UNITED STATES  
NUCLEAR REGULATORY COMMISSION  
WASHINGTON, D. C. 20555

August 18, 1989

Docket No. 50-267

SUBJECT: SUMMARY OF MEETING WITH PUBLIC SERVICE COMPANY  
OF COLORADO (PSC) TO DISCUSS DEFUELING OF  
FORT ST. VRAIN (FSV) JULY 18, 1989 (TAC NO. 73124)

Figure 2-1 Reactor Core Defueling Sequence

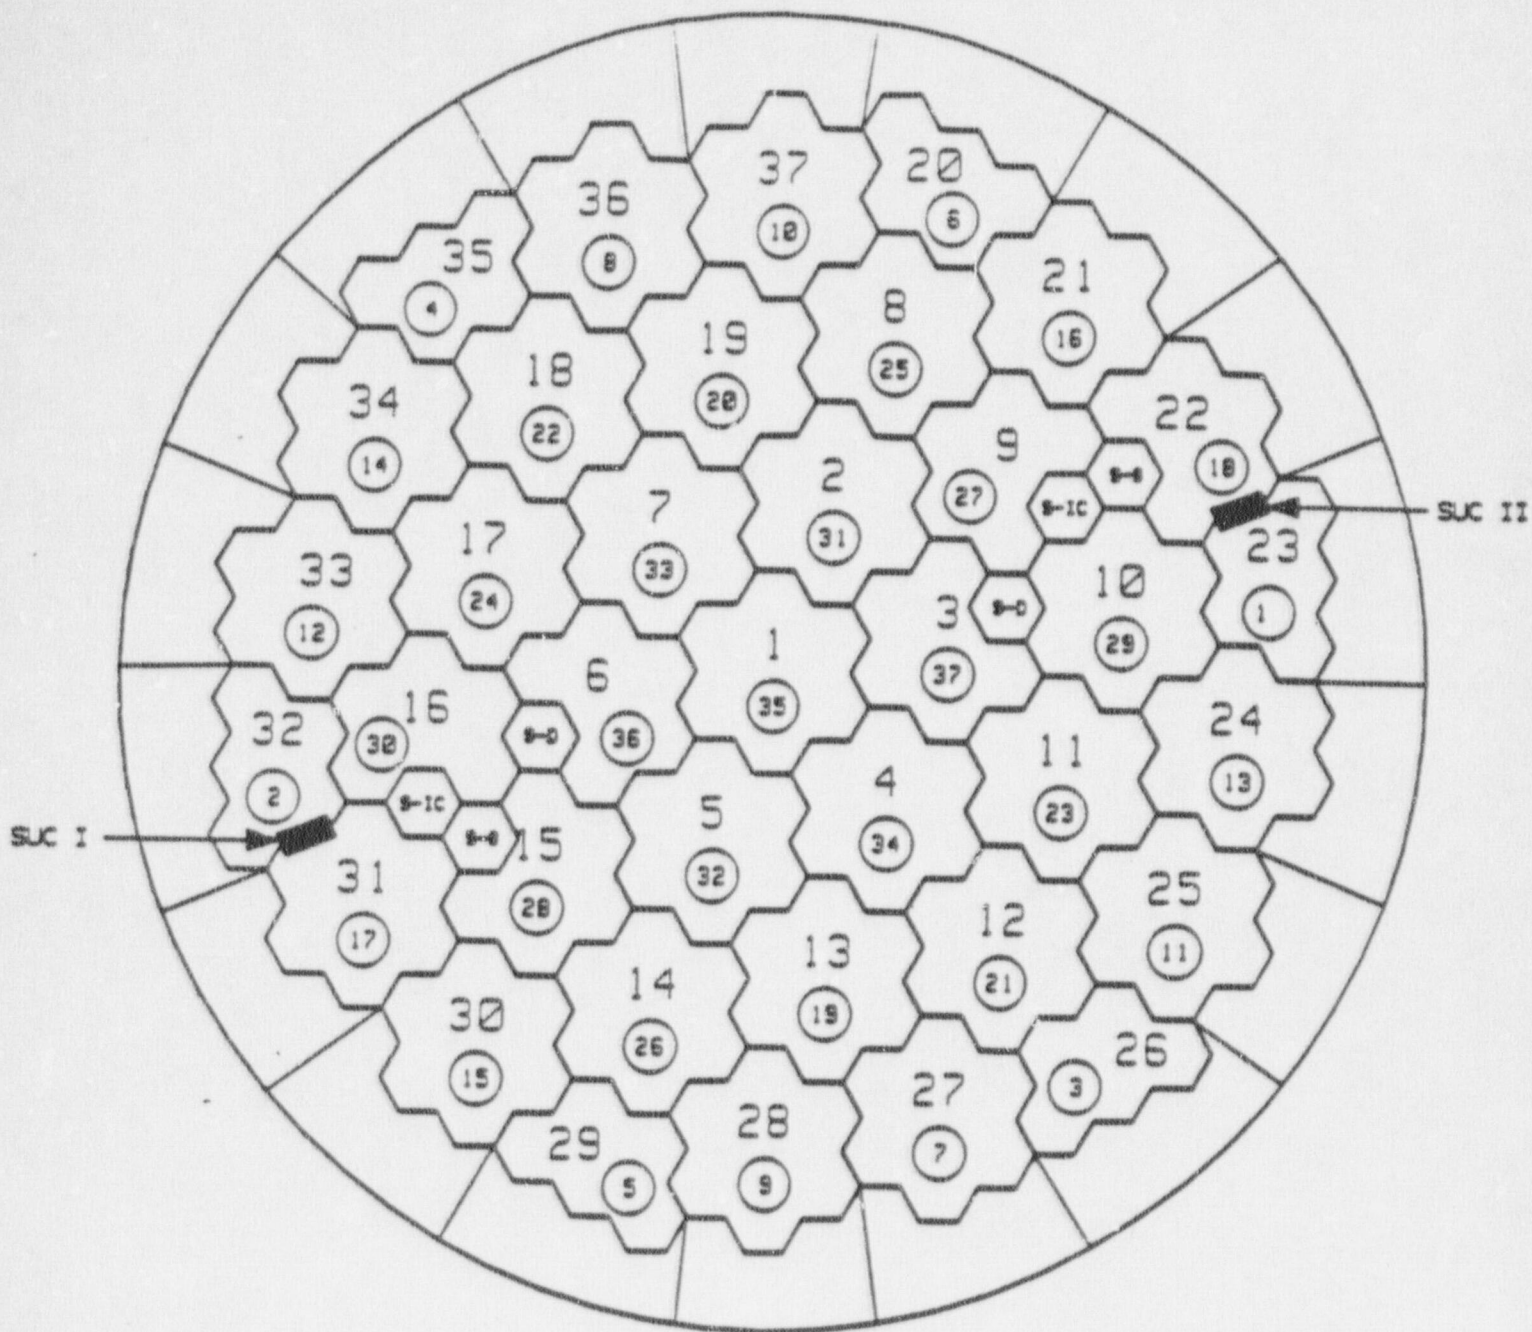
First, the proposals for defueling the reactor are significantly different from the original reactor fueling as defined in the FSV Final Safety Analysis Report (FSAR) (Section 13.3). The fueling was done by layers with temporary absorber strings. The defueling is proposed to be by core regions with a radially inward pattern. Hence, the defueling would differ significantly from previously described fueling and refueling activities.

- Defuel by ring - outer to inner
- Shrinking core concept maintaining right circular cylinder configuration
- Regions 3 and 6 which contain neutron sources are the last regions to be defueled

Figure 2-2 Defueling Element Top View (Dowels Not Shown)

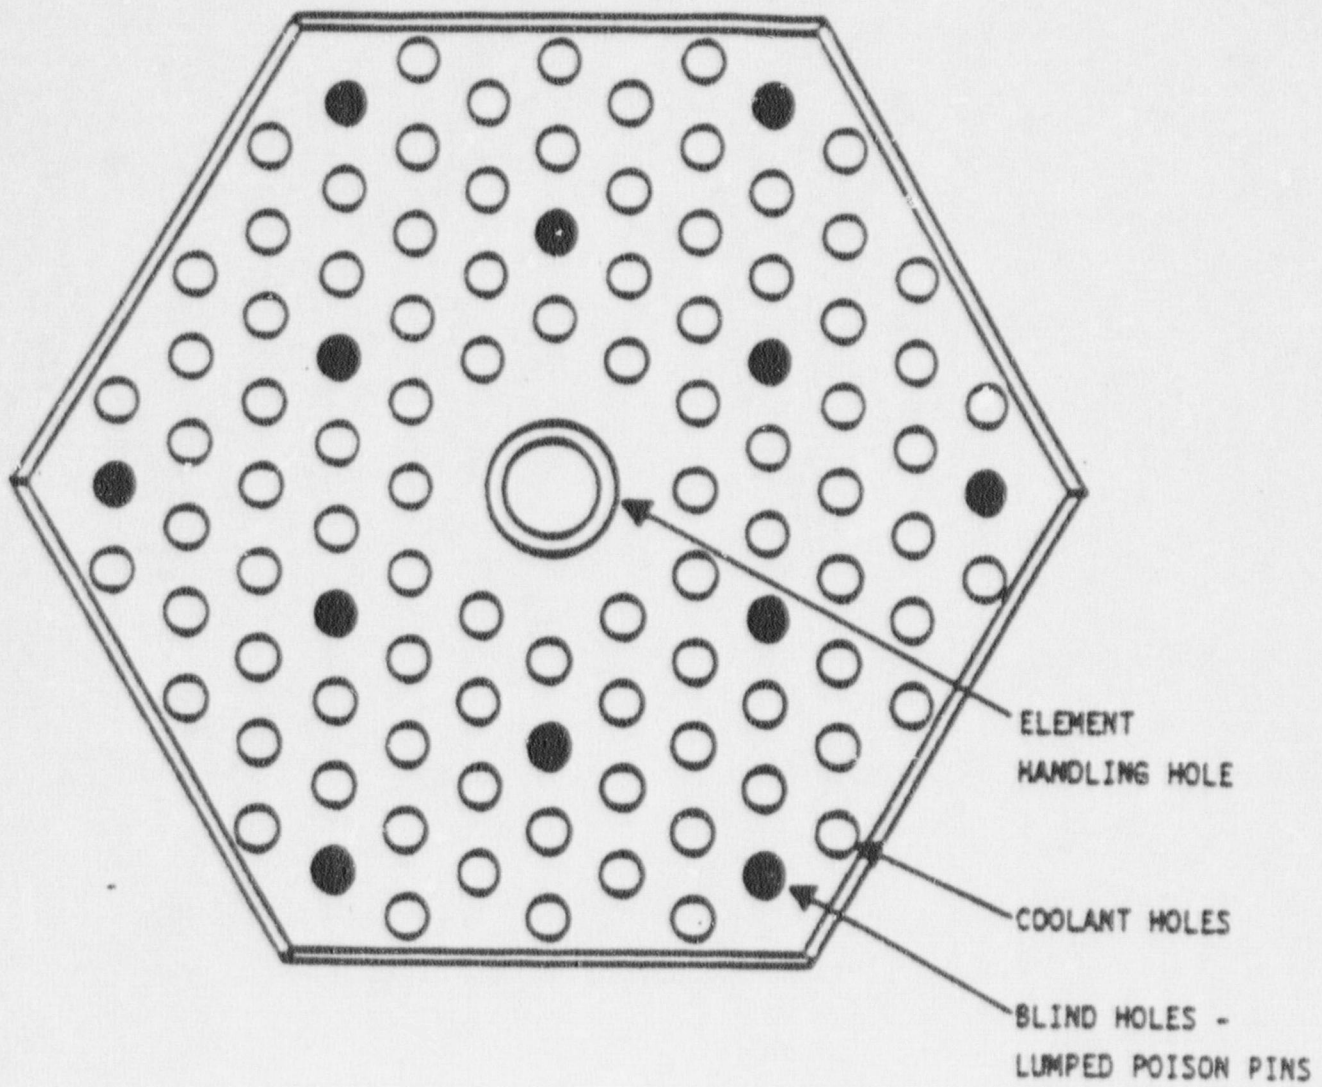
discussions on March 7, 1989 concerning FSV defueling, PSC proposed the use of dummy fuel blocks containing boron material. As the defueling process proceeded, the absence of fuel and its replacement with the dummy fuel blocks would play an increasing and significant role in maintaining the core subcritical (i.e., providing reactivity control). Once a core region is defueled, the dummy fuel blocks provide the negative reactivity. In addition, the dummy fuel blocks maintain the structural integrity of the core. However, the dummy fuel blocks are not described in TS Section 6.1 - Reactor Core - Design Features. The materials of construction are changed from those specified.
